Rio Algom Mining LLC

Re: **License SUA-1473, Docket No. 40-8905**
Proposed Modification to Environmental Monitoring Program

License SUA-1473 Docket 40-8905
Proposed Relocation
of
Existing Environmental Monitoring Location

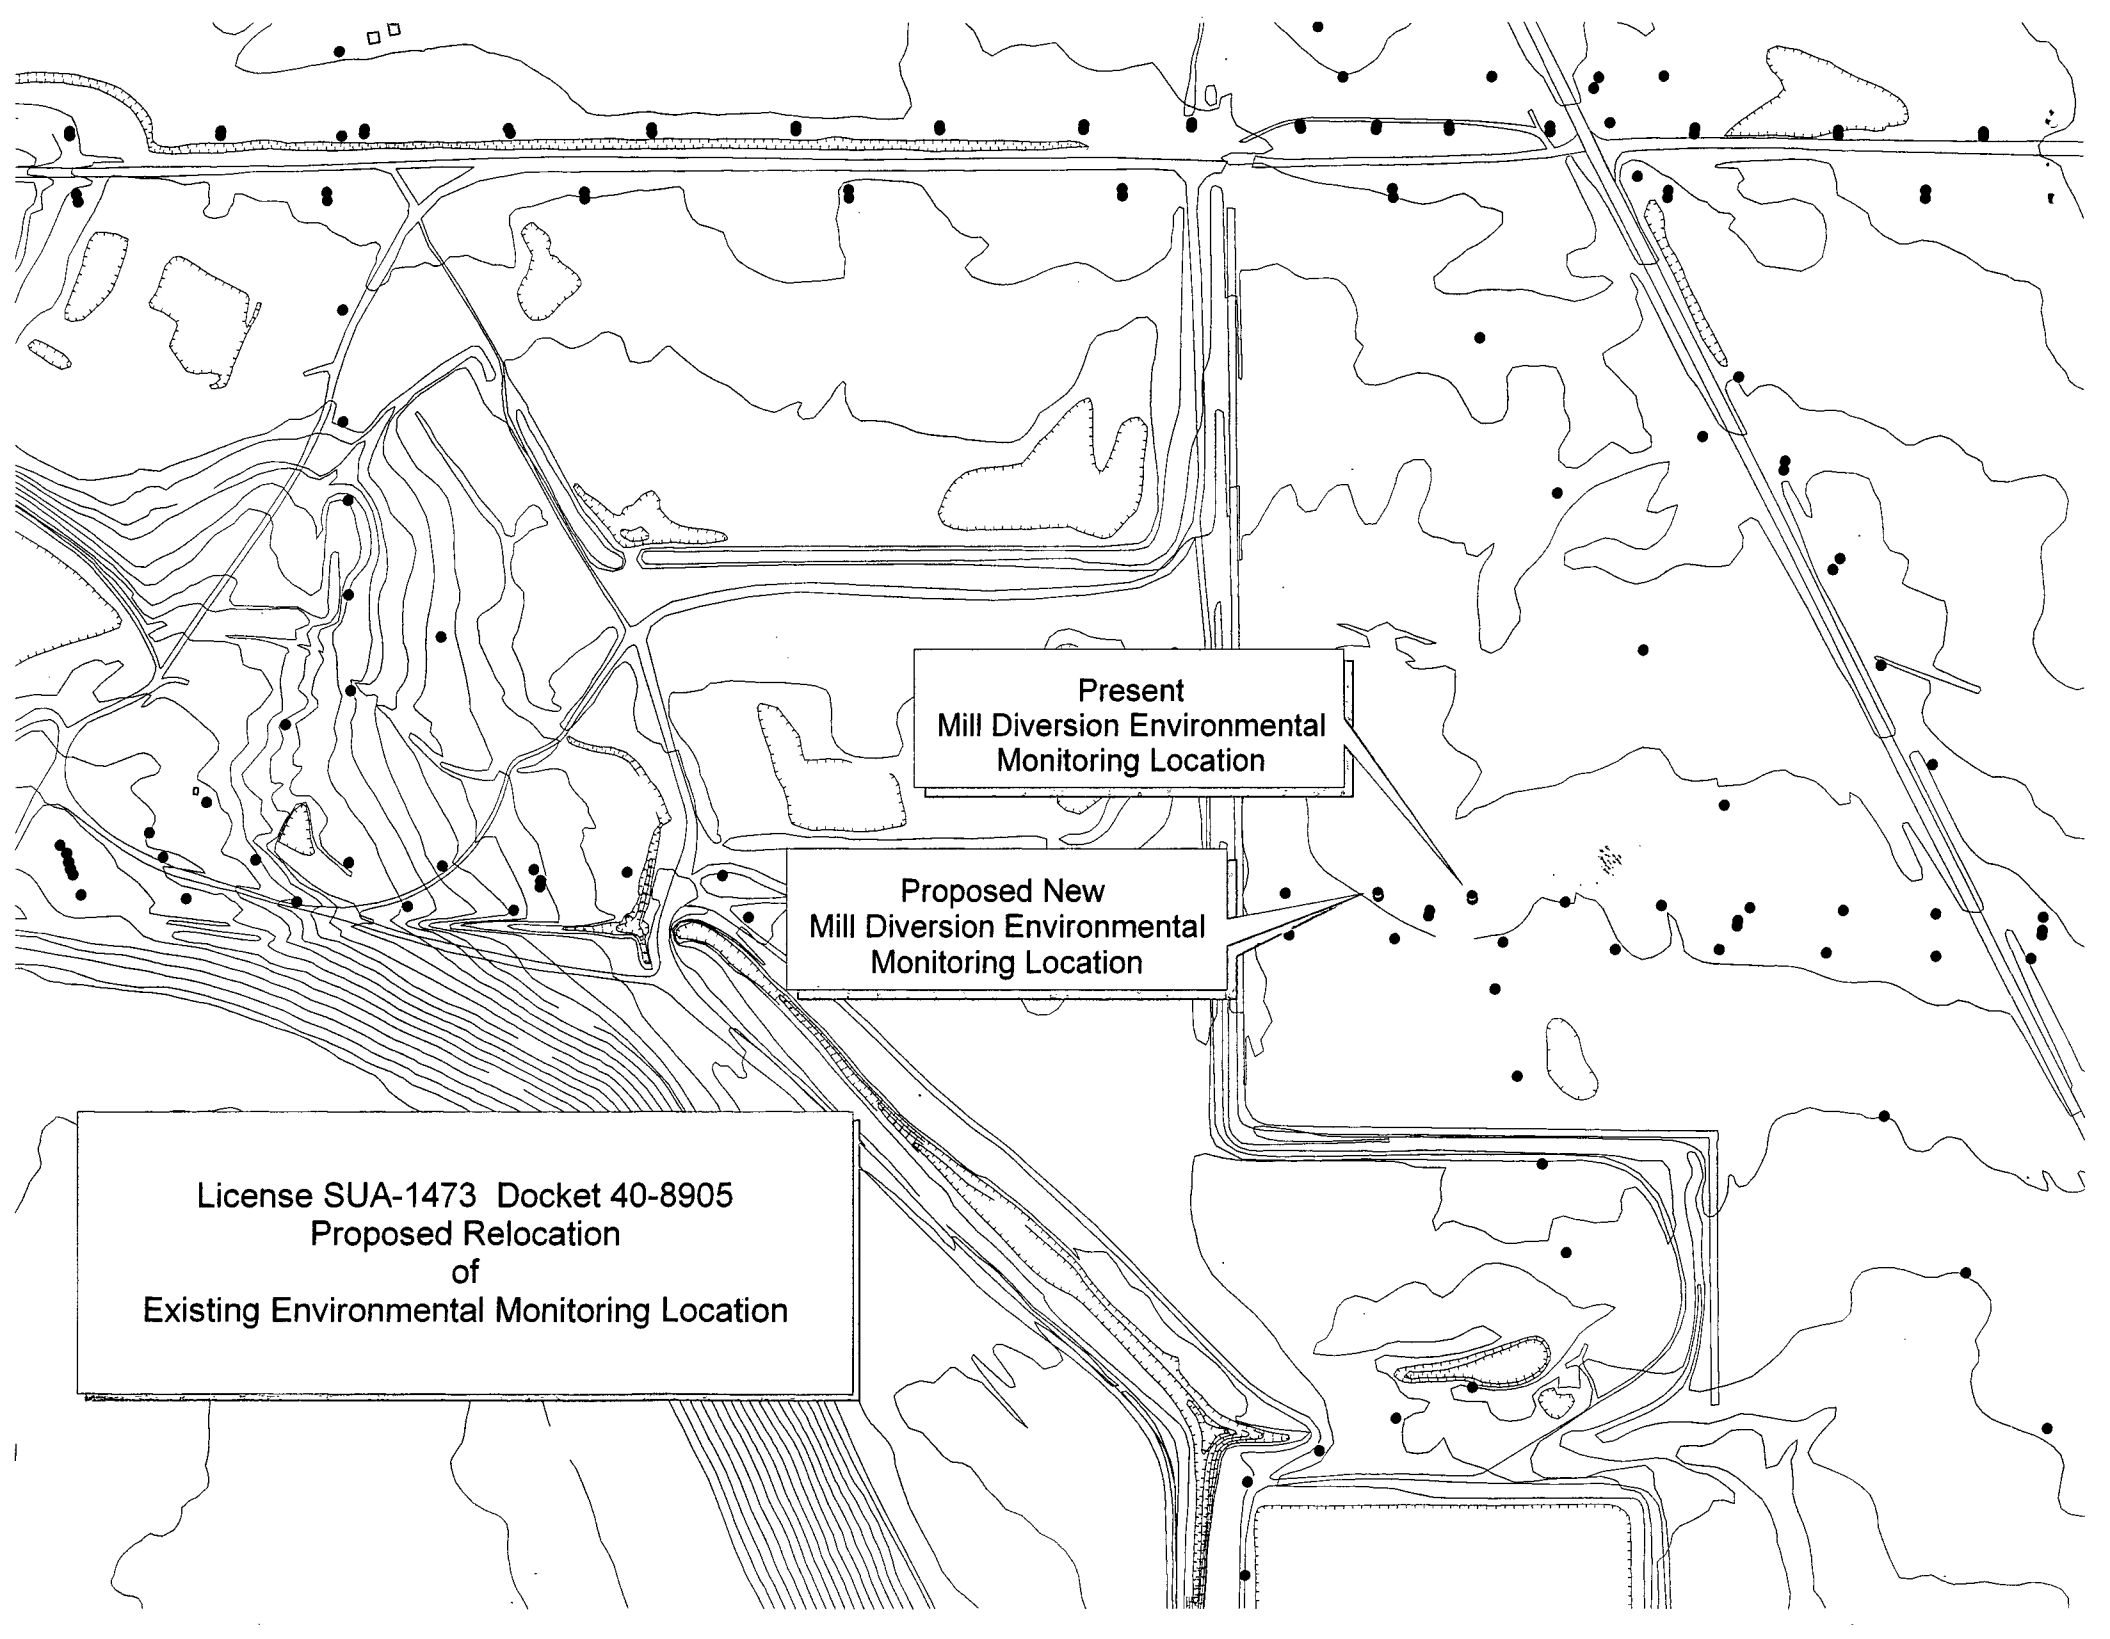
By this letter Rio Algom requests NRC approval to relocate the south diversion environmental monitoring station established at the Ambrosia Lake facility. Relocation of the existing station is necessary to allow for ongoing reclamation construction activities to proceed. Rio Algom intends to relocate the station approximately 250 feet west of the present location. See attached drawing.

Present
Mill Diversion Environmental
Monitoring Location

Proposed New
Mill Diversion Environmental
Monitoring Location
